PLANT NAME: Nine Mile Point Unit #1

ENCLOSURES:  
Proposed Change to Technical Specifications:  
Densification Analyses and Related Technical  
Specifications Changes for Type 5 and Type  
6 Fuel

Re: Nine Mile Point Unit 1  
AEC Docket No. 50-220

FIGURE 3.1.7. e MAXIMUM ALLOWABLE AVERAGE PLANAR LHGR  
APPLICABLE TO FUEL TYPE 5 and 6

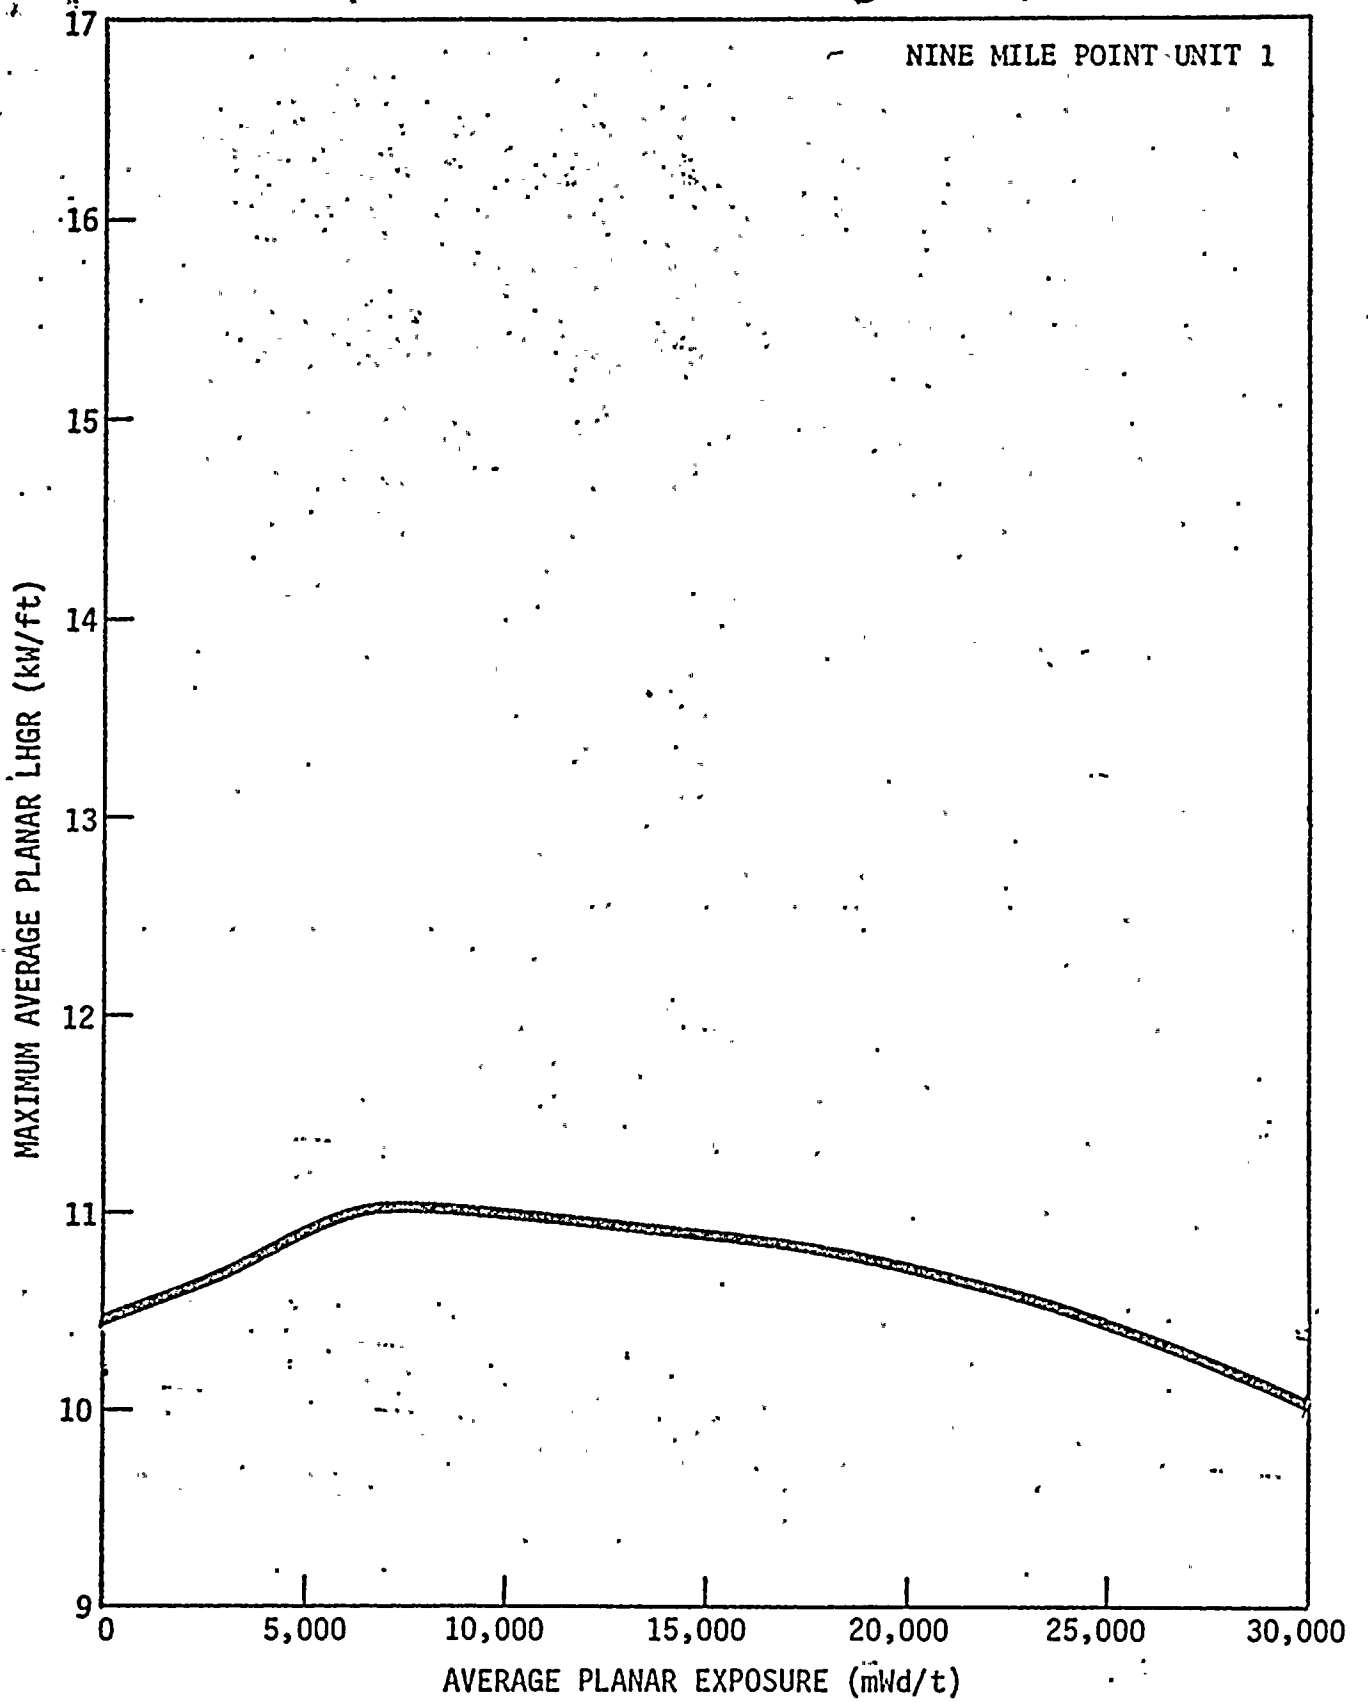
### Change A

Add the attached Figure 3.1.7e to the Technical Specification. Under the Limiting Condition for Operation 3.1.7, add Figure 3.1.7e to the list of figures at the end of the last sentence in paragraph a.

Add Figure 3.1.7e to the list of figures in the third paragraph of the Bases 3.1.7a.

The results of analyses performed for 8x8 reload fuel has indicated that limits on MAPLHGR and power spiking penalties due to densification are required. These limits as they apply to Type 5 and Type 6 fuel are presented for incorporation into Nine Mile Point Unit 1 Technical Specifications.
